PLANS AND DOCUMENTS
referred to in the PDA
DEVELOPMENT APPROVAL

Approval no: DEV2025/1591

client LEG CONSTRUCTIONS
drawing BUILDING 4
THIRD FLOOR PLAN
project NEW TOWNHOUSE/ UNIT
DEVELOPMENT
address 3 MOORES ROAD,
REDLAND BAY Q 4165

AMENDED IN RED

FLOOR PLAN
GROUND FLOOR

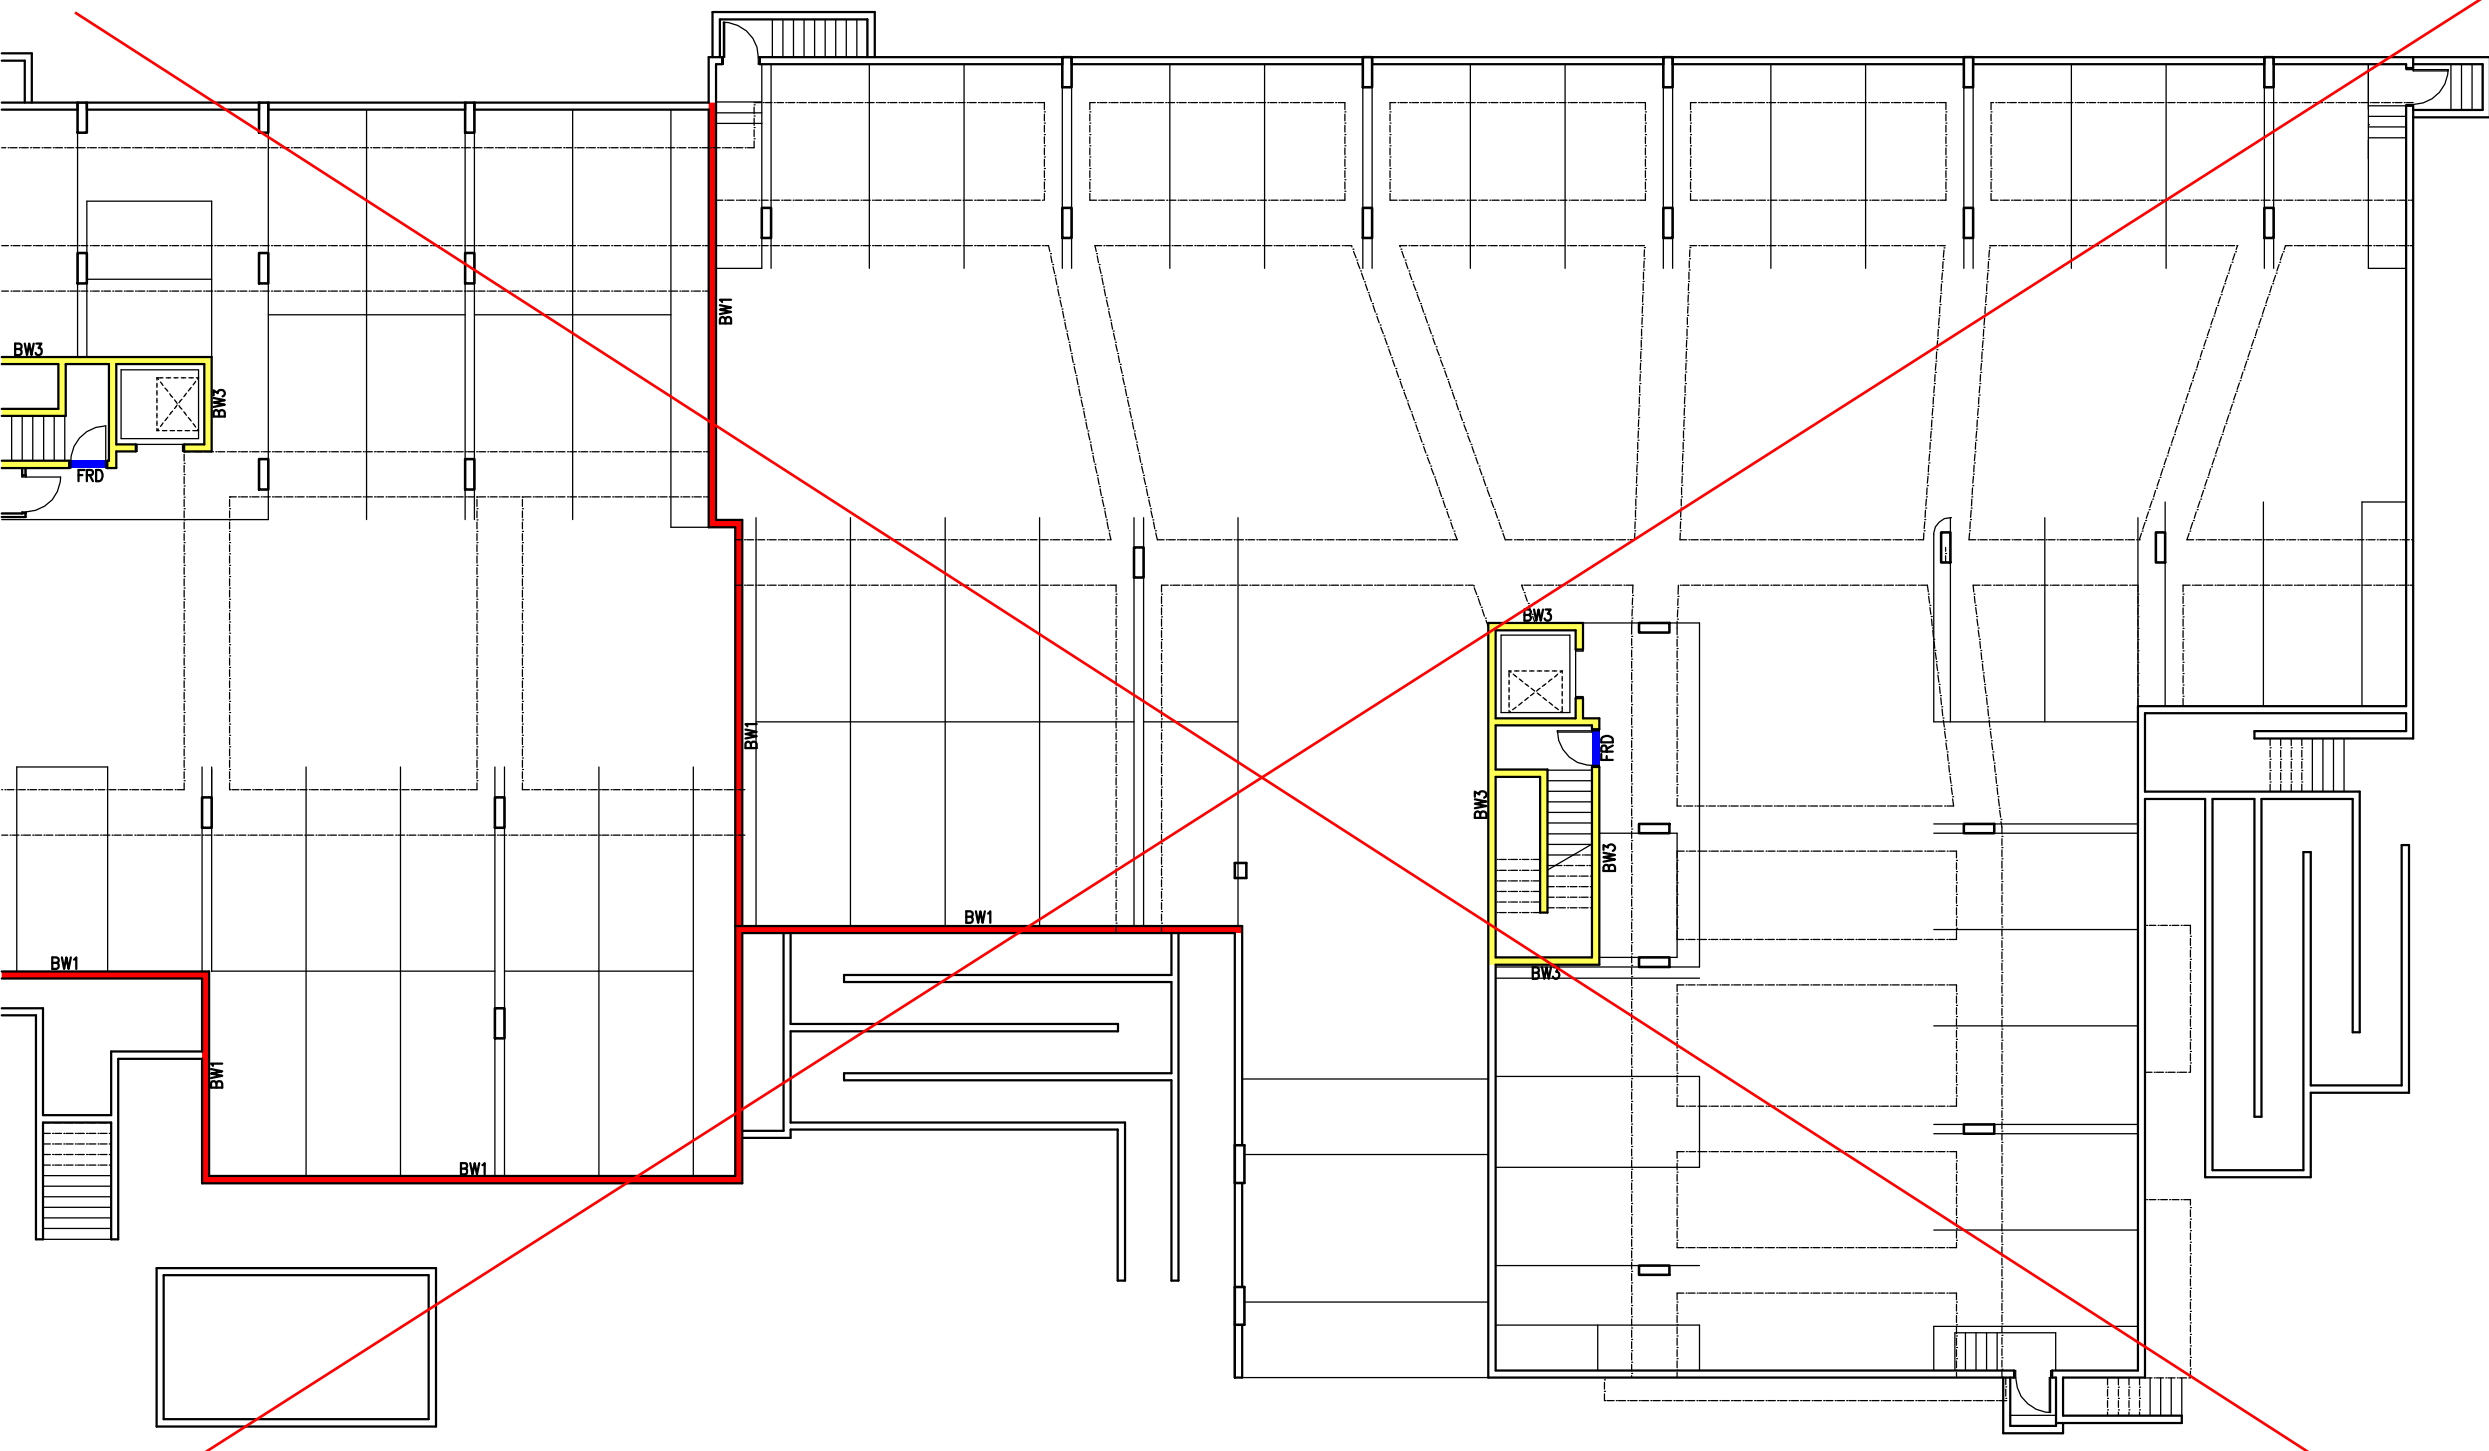
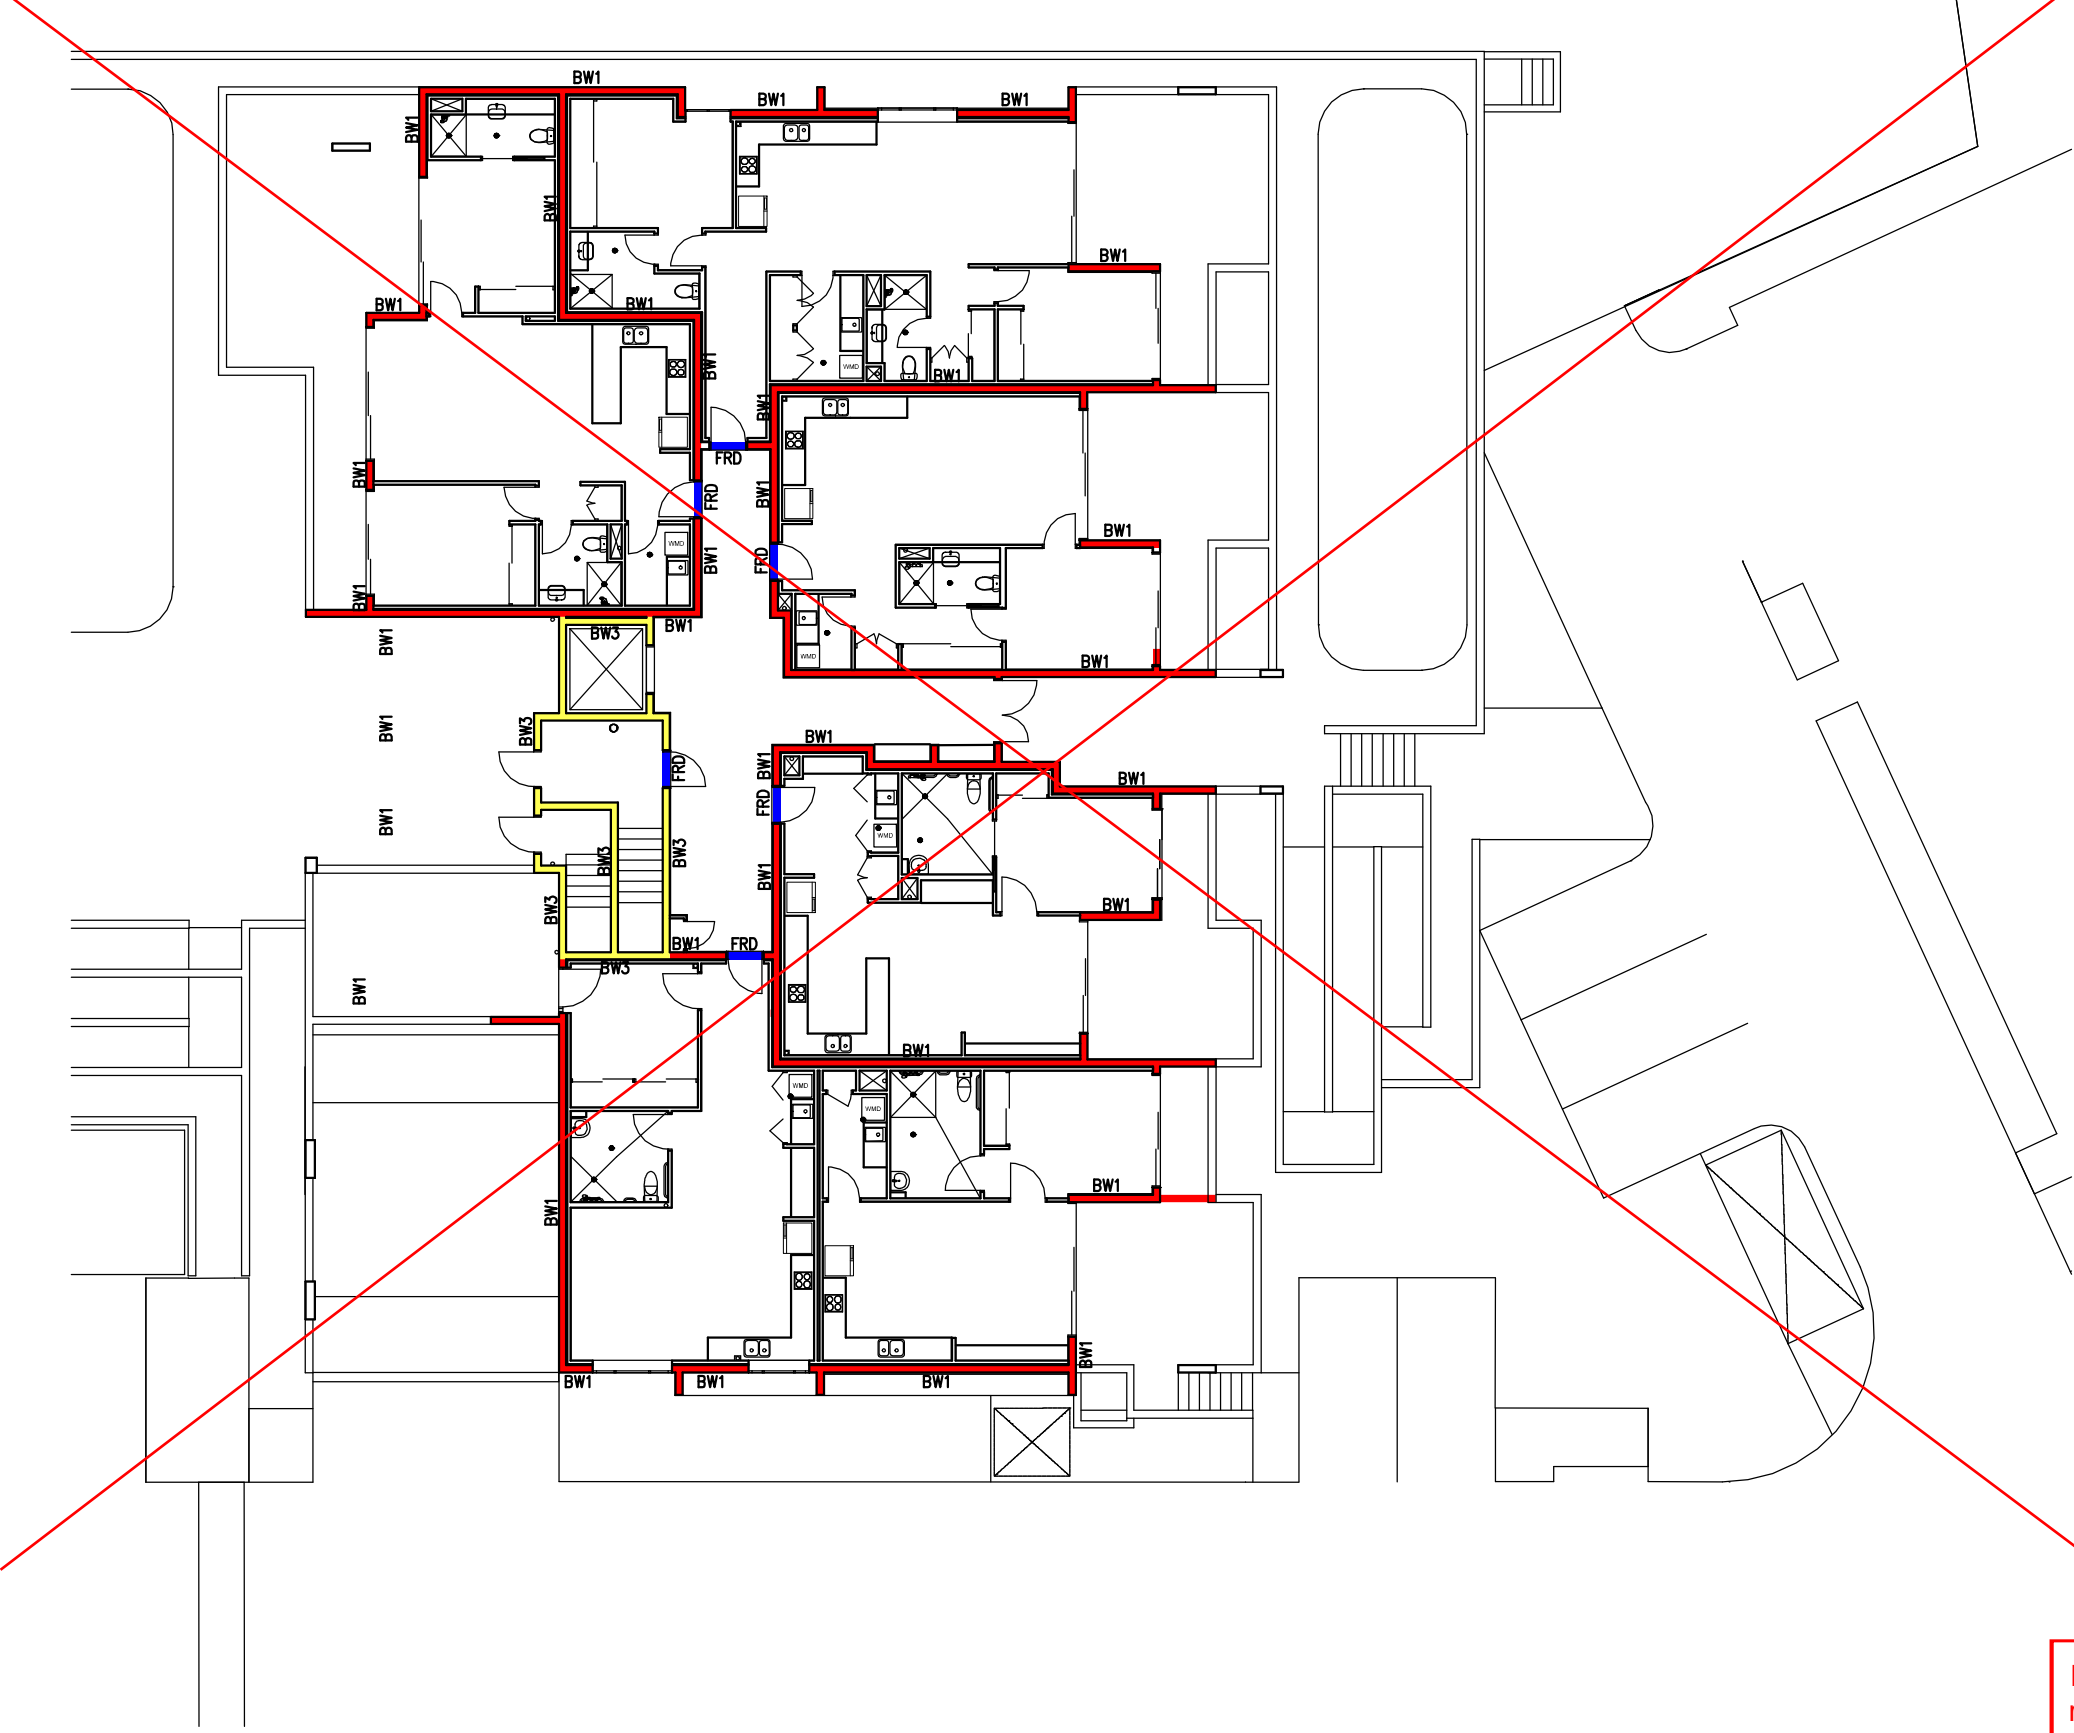
Crossed out floors not part of this approval. Refer to DEV2020/1093

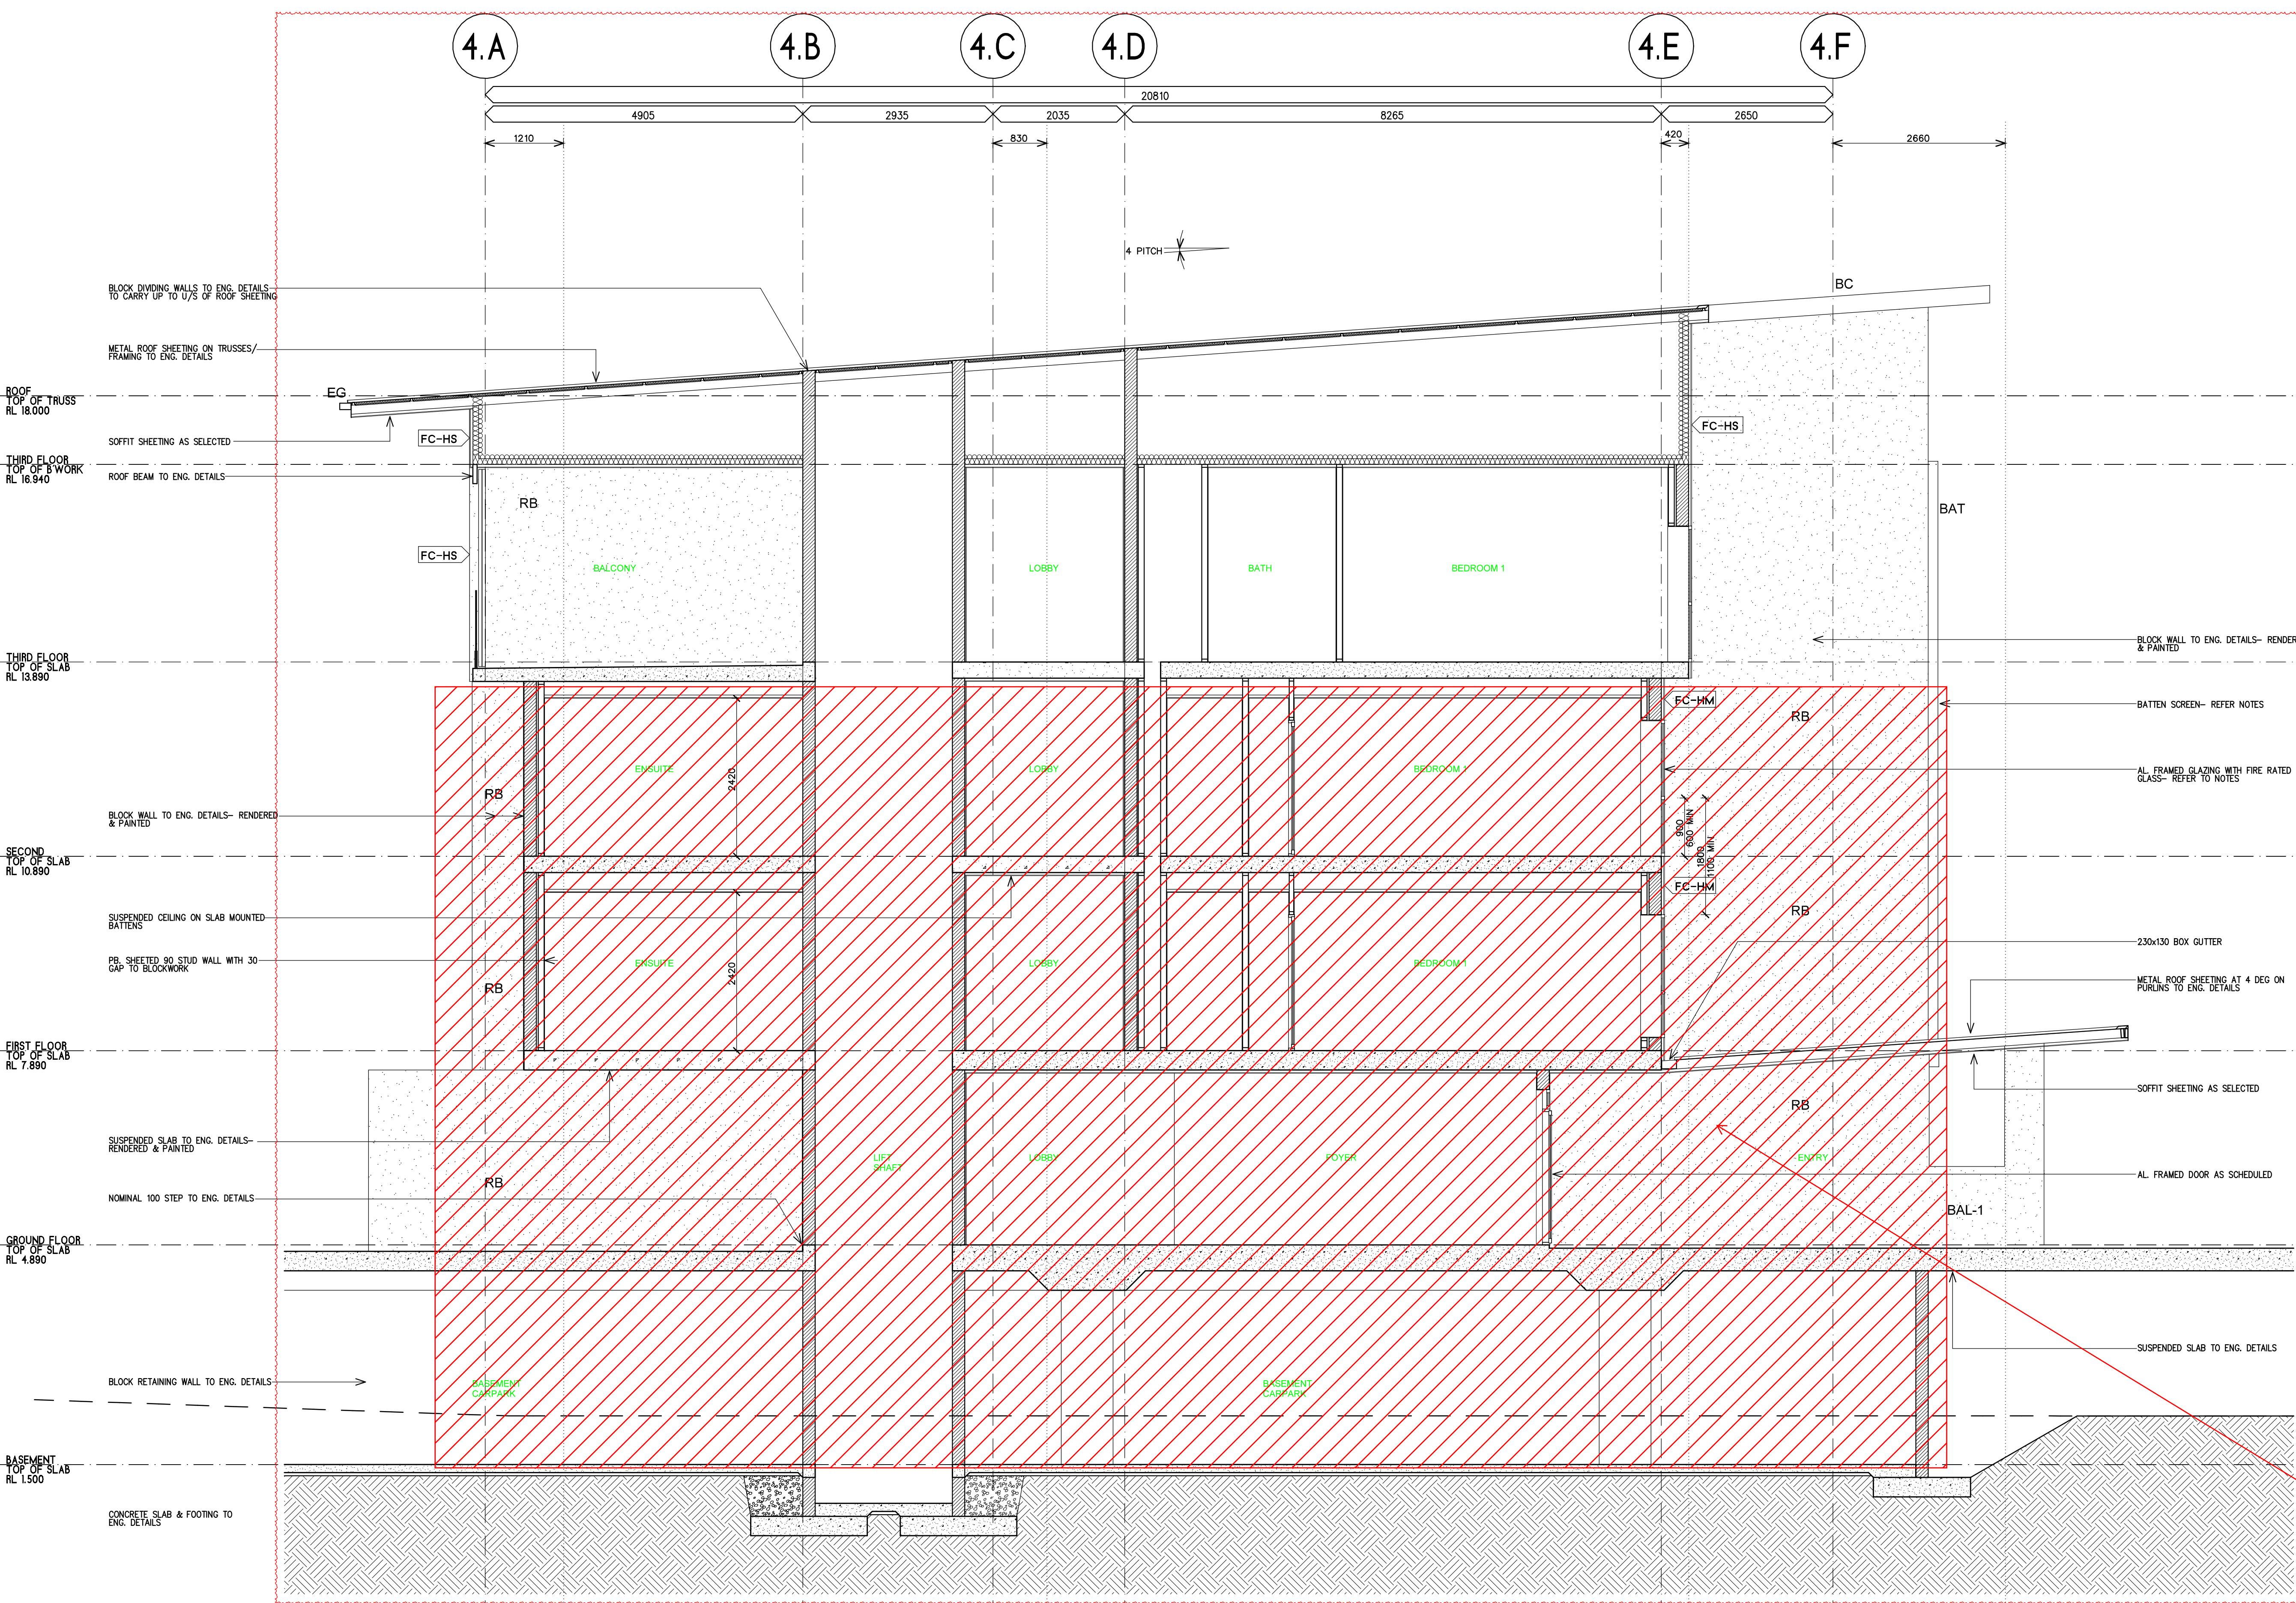
AMENDED IN RED
